Coffs Harbour Bypass

Amendment Report

Volume 1A. Executive summary, Chapters 1-4

Coffs Harbour Bypass
North Boambee Valley vertical alignment
Figure 2-4

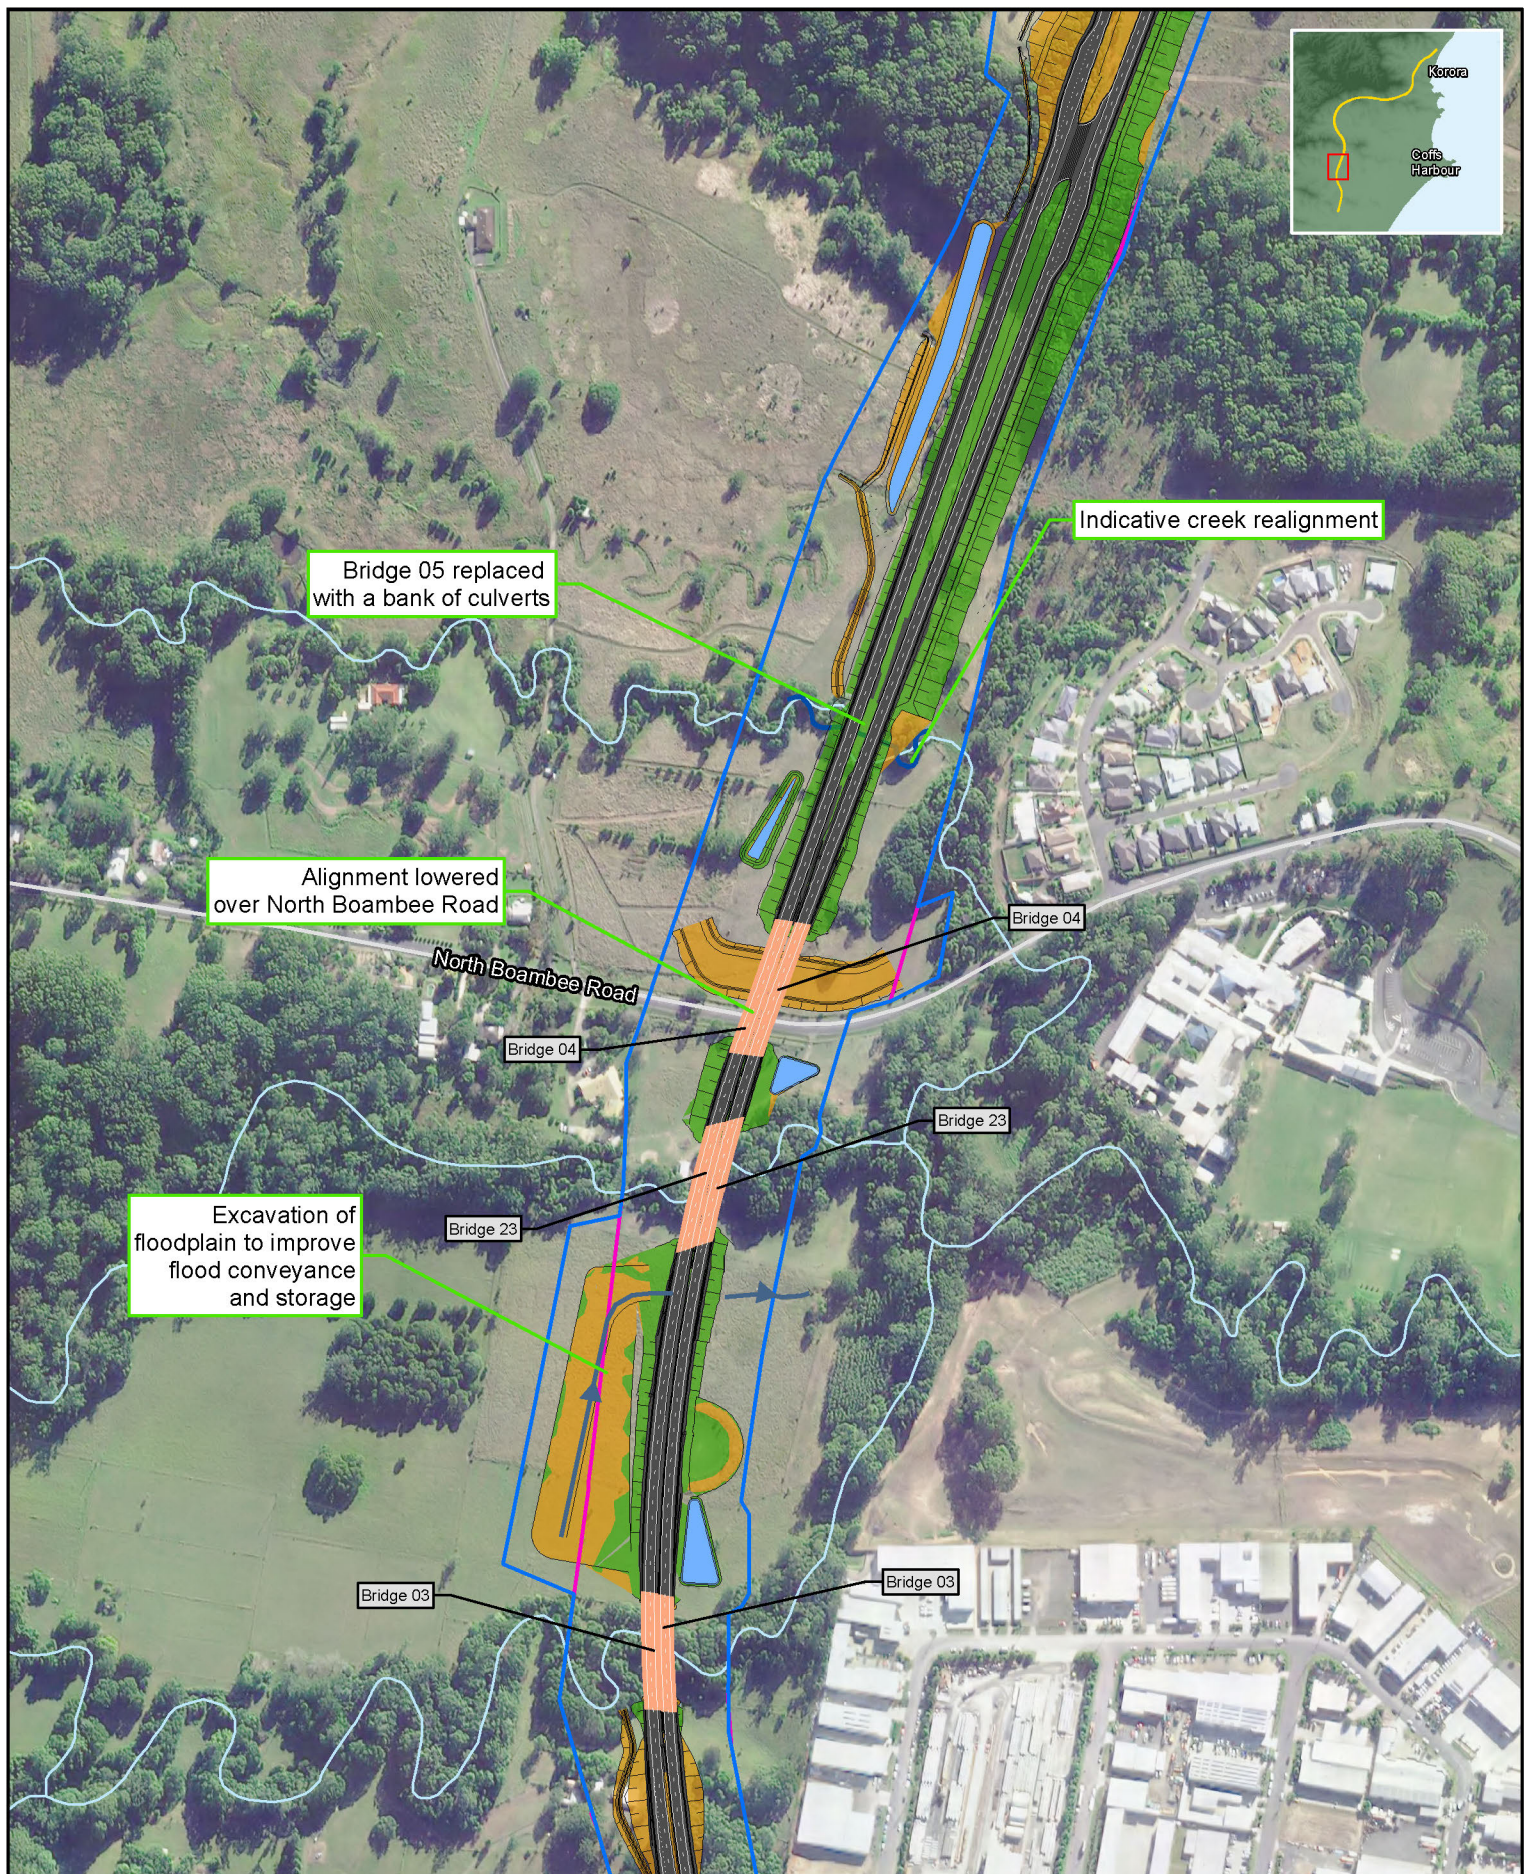
The design changes through the North Boambee Valley are shown in **Figure 2-4** and comprise:

- Lowering the vertical alignment of the project. A minimum clearance of 4.6 metres would be provided over North Boambee Road to maintain access. TfNSW would continue to consult with CHCC about clearance requirements for North Boambee Road, which would include provision of a minimum clearance of 4.6 metres and route which is flood free in the 5 per cent annual exceedance probability (AEP), as part of the whole of government approach to manage flooding in North Boambee Valley

- Changing BR 05 from a 64 metre long bridge to a bank of box culverts. The culverts would consist of six 2.4 metre x 2.4 metre box culverts about 45 metres long. The culverts would require about 130 metres of the northern tributary of Newports Creek to be realigned as it passes through the culverts beneath the project. The realignment would include a low flow channel to provide for fish passage, including through one of the culverts beneath the carriageways, which would be

Coffs Harbour Bypass
Coramba Road bus stop
Figure 2-5

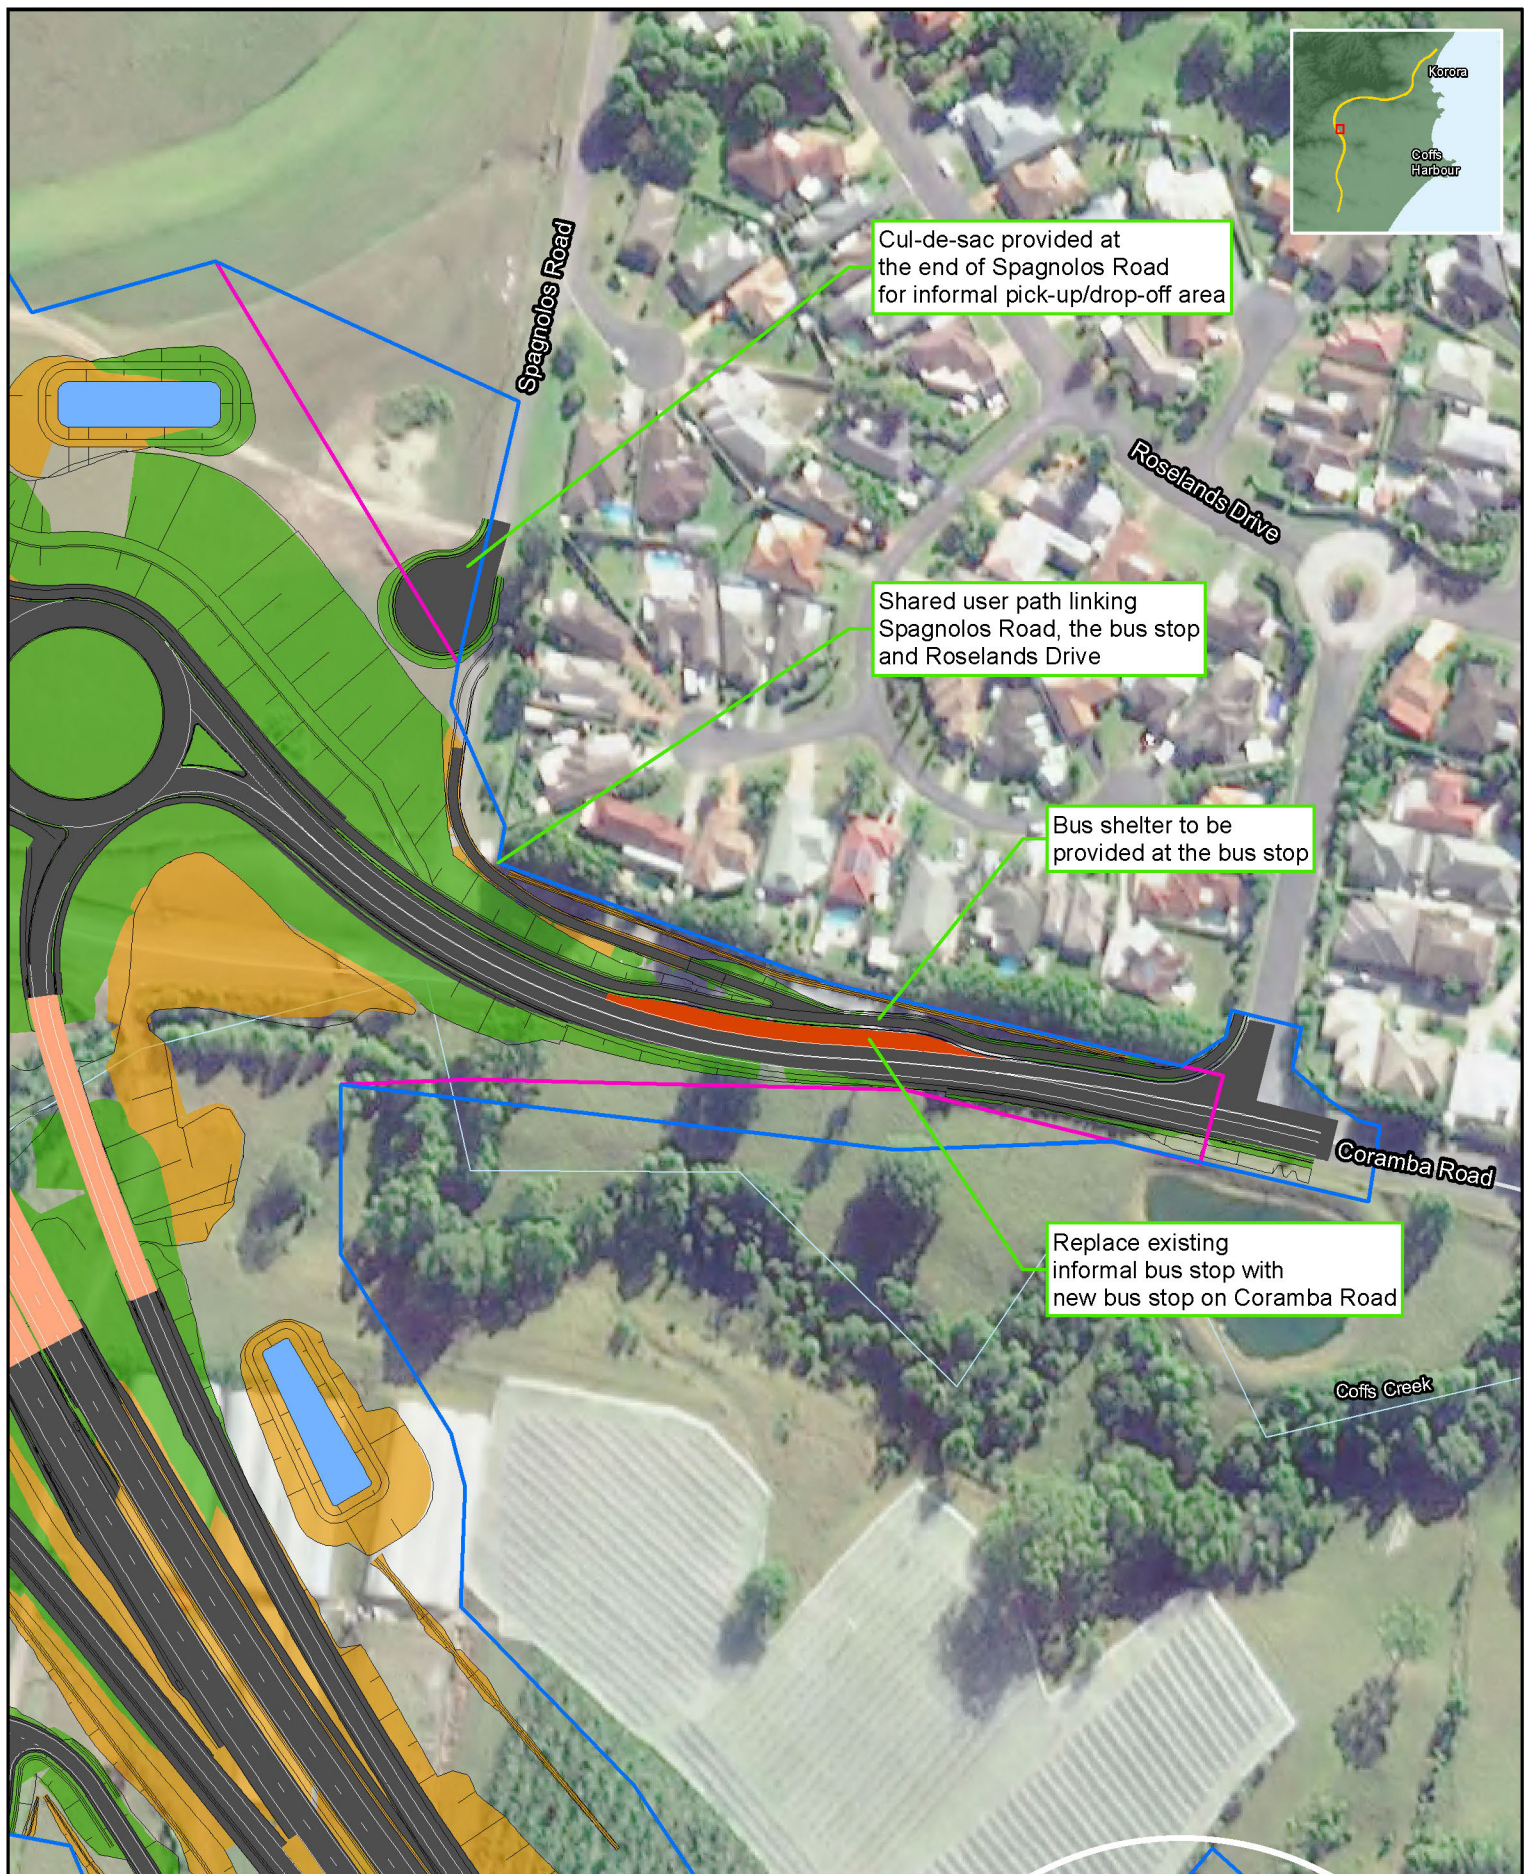
The design changes for the Coramba Road bus stop are shown in Figure 2-5 and comprise:

- Removal of the informal bus stop and a new school bus stop on the north side of Coramba Road and about 50 metres east of Spagnolos Road. The new bus stop would include capacity for four 12.5 metre long buses
- A bus shelter
- A raised concrete median to separate the facility and its users from Coramba Road traffic
- A shared user path to connect Spagnolos Road with the new bus stop on Coramba Road. There would be an overlap in the proposed noise wall to facilitate access to the shared user path
- A cul-de-sac would be provided at the Coramba Road end of Spagnolos Road to provide an informal area for parents and carers to park, pick-up and drop-off children and turnaround.

Coffs Harbour Bypass
Coffs Creek flood mitigation
Figure 2-6

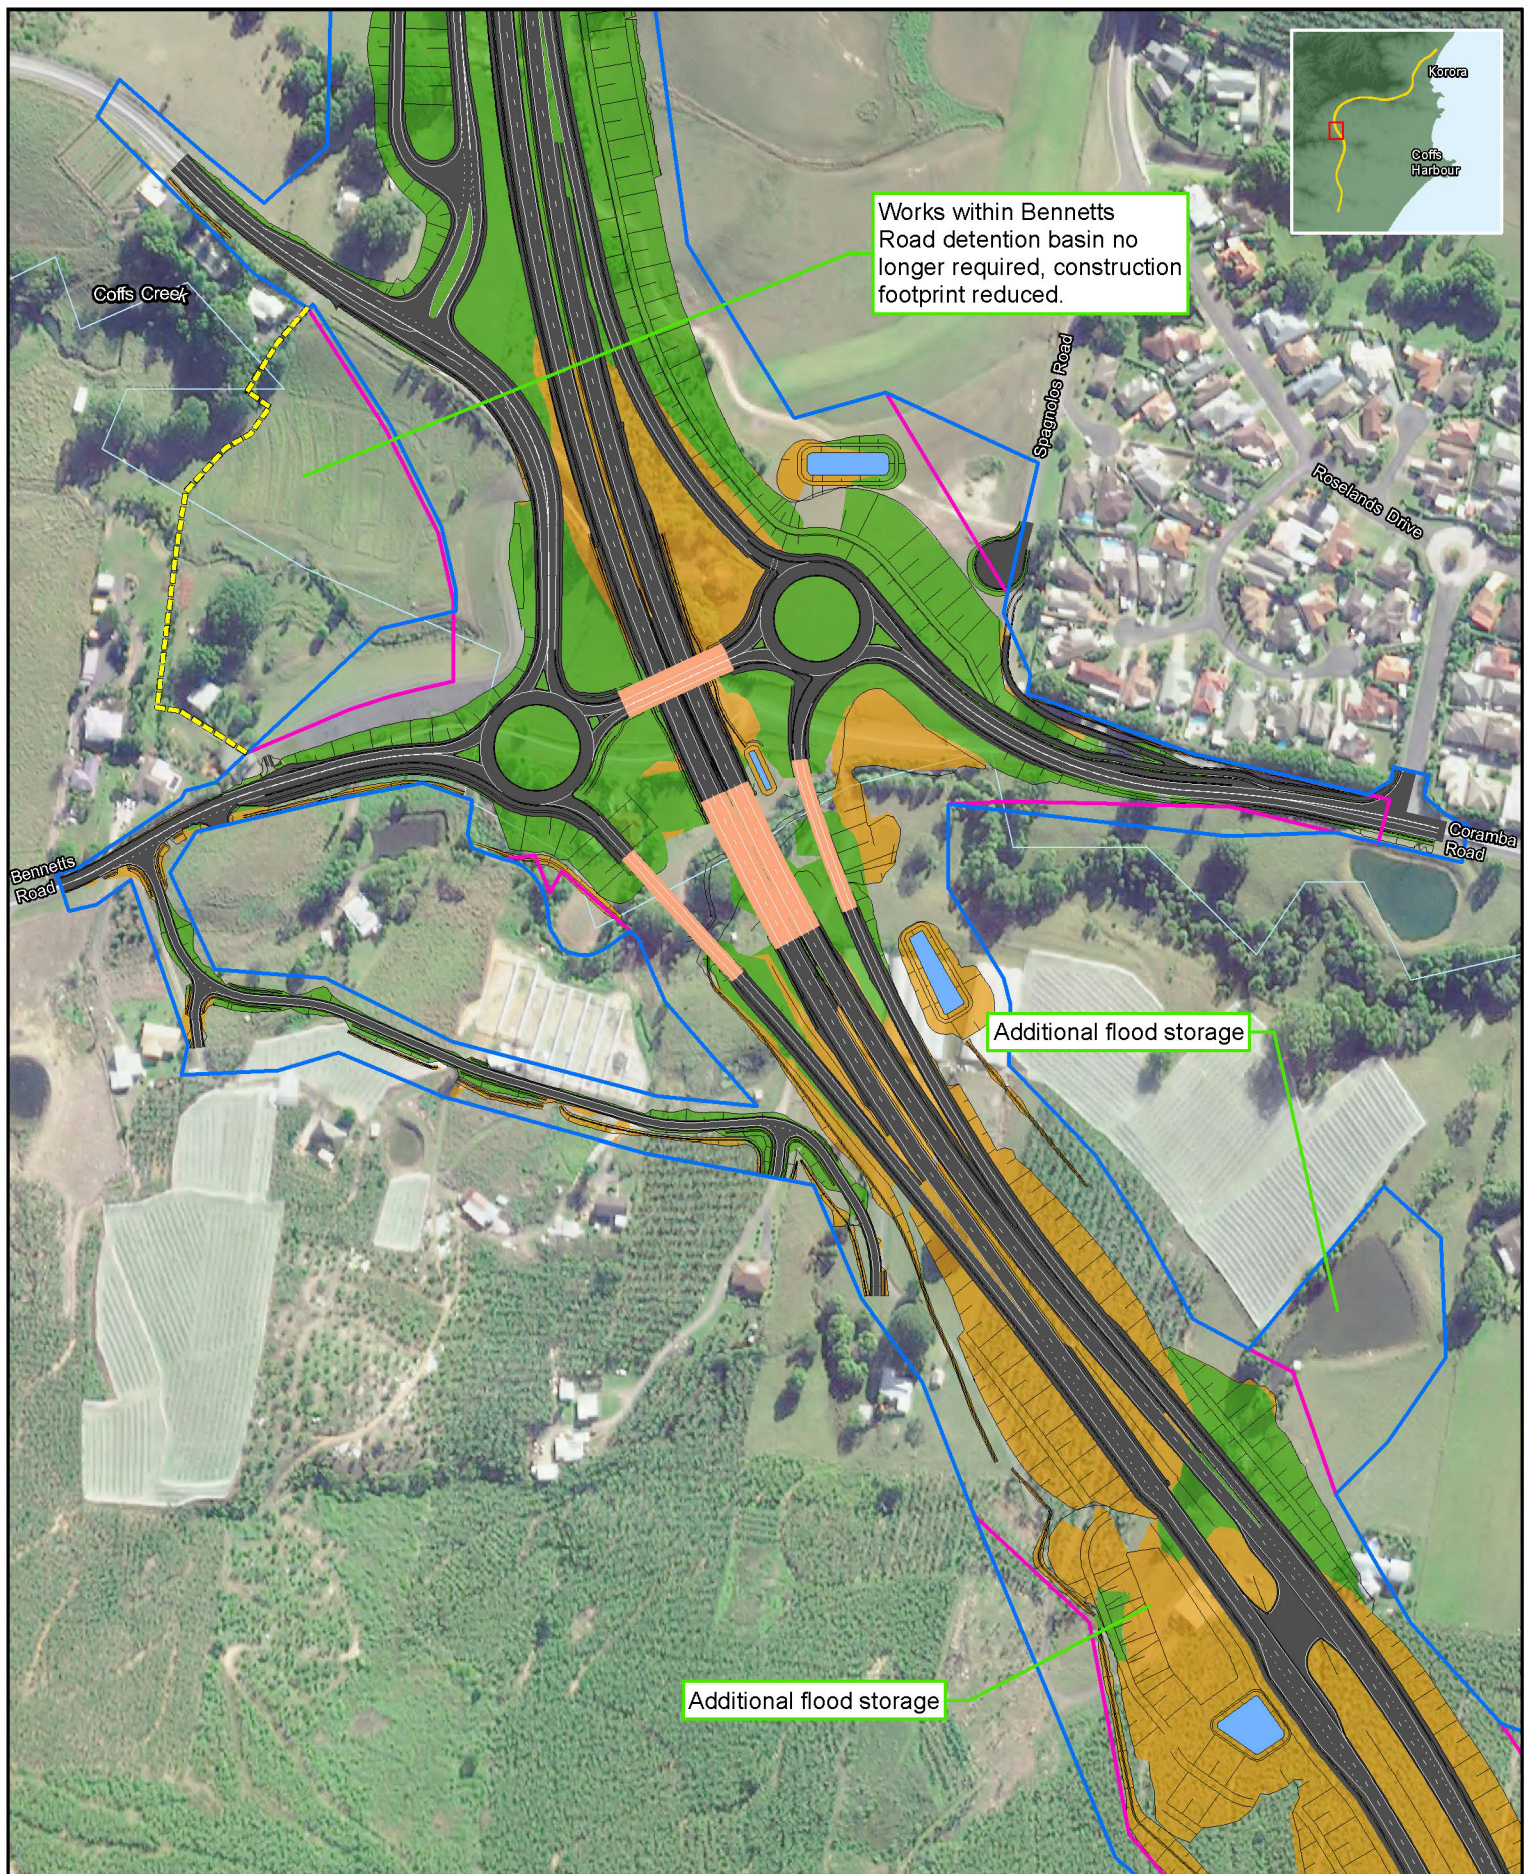
The design changes to the project within the Coffs Creek catchment are shown in **Figure 2-6** and include:

- Excavation of Bennetts Road detention basin to increase the flood storage capacity of the basin is no longer required, resulting in a boundary change which would reduce property impacts for APO36
- Additional flood storage is provided upstream and downstream of the project (about 500 metres south of Coramba Road interchange) to reduce predicted flood levels in Coffs Creek. A farm dam to the east of the project (downstream) would be excavated and would be increased in size to about 11,500 cubic metres. A retention basin would be included to the west of the project (upstream) and the capacity would be about 14,500 cubic metres.
